CONSIDER AN APPLICATION FOR SPECIAL USE PERMIT MODIFICATION FOR UNIVERSITY PLACE, 201 S. ESTES DRIVE (PROJECT # 19-130)

SUMMARY REPORT

**ADDITIONAL INFORMATION FOR THE SPECIAL USE PERMIT
MODIFICATION FOR UNIVERSITY PLACE, 201 S. ESTES DRIVE (PROJECT #
19-130)**

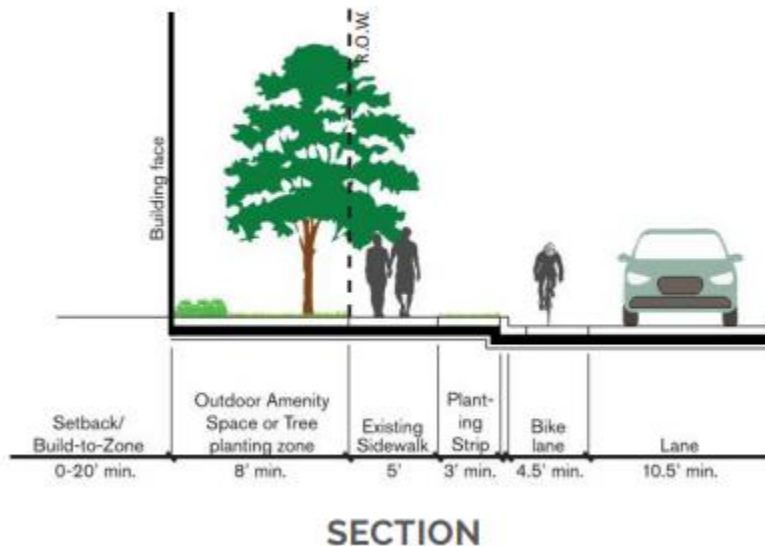
Council discussed additional width for Willow Drive sidewalk. The existing five (5) foot sidewalk is proposed to remain along the Willow Drive frontage as shown in the cross-section below:

The developer has indicated that widening the sidewalk beyond the existing five (5) feet may jeopardize the existing trees lining Willow Drive. Additionally, the developer has proposed ten (10) foot multi-use paths along both Estes Drive and Fordham Boulevard (US 15-501). The developer has provided additional cross-section details that can be found in the Applicant's Materials.

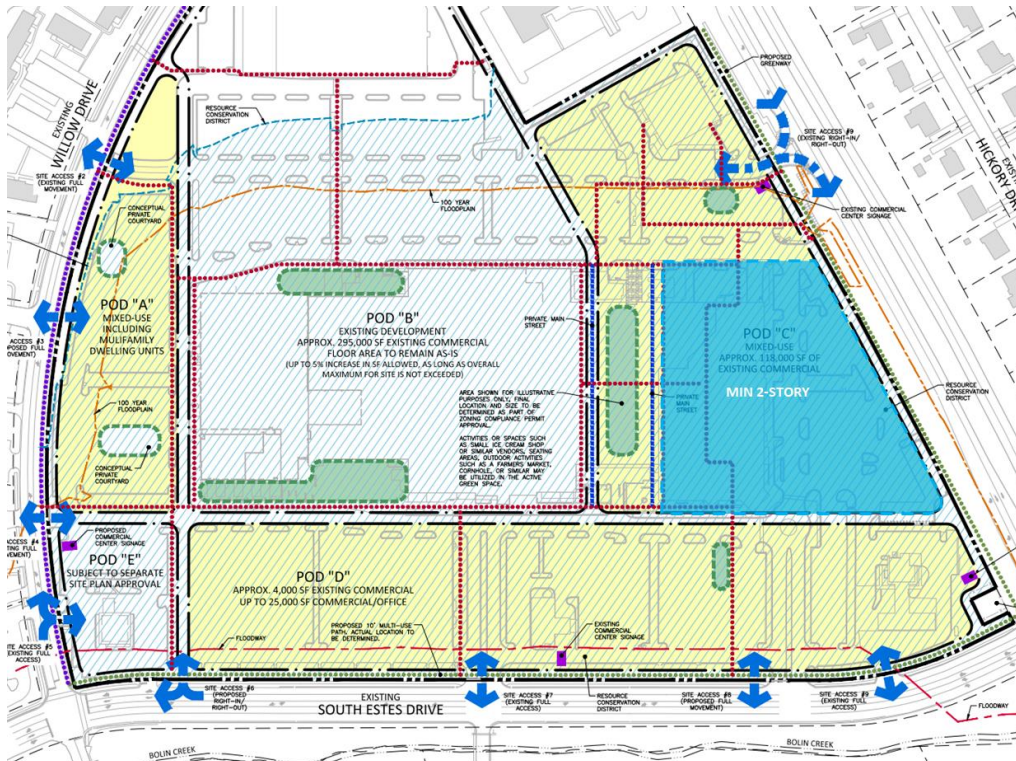
- New constructed stand-alone buildings shall be more than one story in height.

Applicant Response: We have proposed requiring two story buildings only within the specified area of Pod C. This was the area where the board was requesting 2-story. Please see the diagram below indicating Pod C.

Staff Response: The following stipulation has been added to Revised Resolution A:
